INDESIT company

Model type:
WIL105XEX

Commercial code:
F030539

N1040319FIG1

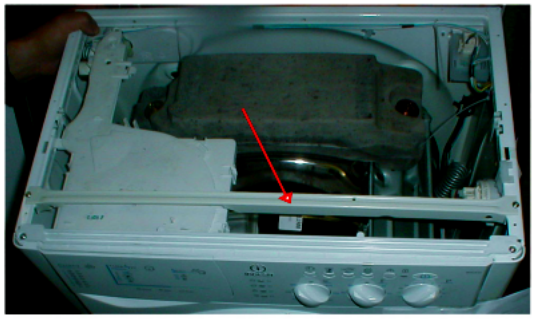
n1040319: Elimination of metal bar on INDESIT cabinets.

From serial no. 40223.0001 Indesit EVOII Washing Machines produced in the Comunanza - Brembate factory have been equipped with a wooden reinforcing strip on the top, whereas the metal bar on the cabinet has been eliminated.

The modified tops have the same Service code as premodification items (096937, 097617, 098440, 099929 and 097806).
When using the new top on a premodification appliance the metal bar (see N1040319FIG1) must be removed, whereas the old top can be used in place of the new one without any modification.
The new top can be used in place of the old one and vice versa; the Service code remains the same.

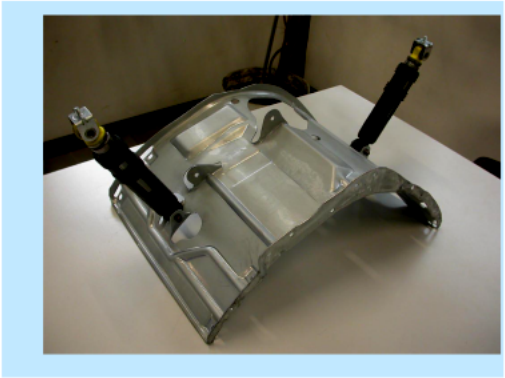
n1040325: New shock absorber fixing system with pin

From serial no. 40427.0001, shock absorbers have been fixed to the tank unit cradle with two 11 mm pins code C00110163 (see fig. 01 and 02 enclosed) in place of the 8 mm screws code 093750 and relevant locking nuts code 030443, on all washing machines and dryers produced in the Comunanza factory.
The items affected by this modification are:
1) The cradles have the same Service code, as they can be used in place of the new ones after widening the shock absorber fixing holes to a diameter of 10 mm.
Code 093848 - Tank unit cradle 46 lt
Code 093878 - Tank unit cradle 40 lt.

2) The new shock absorbers, with fixing bushing having no s/steel spacer, are not managed as they are interchangeable with the premodified items (make sure they are CIMA type, as the managed items), fixed with M8 screws code 093750 and related locking nut code 030443 (see figs. 05 and 06).
Code 093884 - Shock absorber 80 N
Code 093885 - Shock absorber 100 N

To remove the shock absorber from the tank, first extract the pin with a few hammer taps (see fig.03) until it is aligned with the tank bracket and then pull it out with a pair of pliers (see fig. 04).
(To refit the shock absorber use a new pin. Insert the pin until the toroidal edge is aligned with the bracket.)

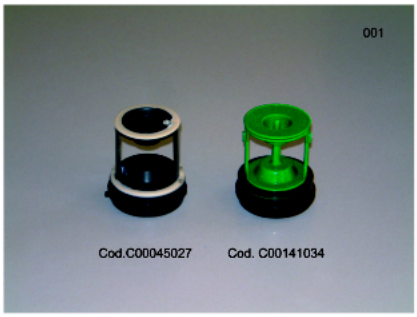
n1040359: Polar White Factory 80 (Comunanza)

From serial no. 50315.0001, the new "Polar White" colour is used on all washing machines and washer-dryers produced in factory 80 in place of White 27.
The third last number of the Industrial Code given on the rating plate of the modified models is 9 (e.g. 80286390900).
To determine the new Polar White codes, it is necessary to know the industrial code or serial number of the appliance being repaired.
The new items, which bear the initials "PW" in place of "B27", are not aesthetically interchangeable with premodification items as the whites are different. Both colours will be available for some time.
The items affected by this modification are:
Body, rear panel, top, control panel, handles, buttons, knobs, knob disc, door and plinth.
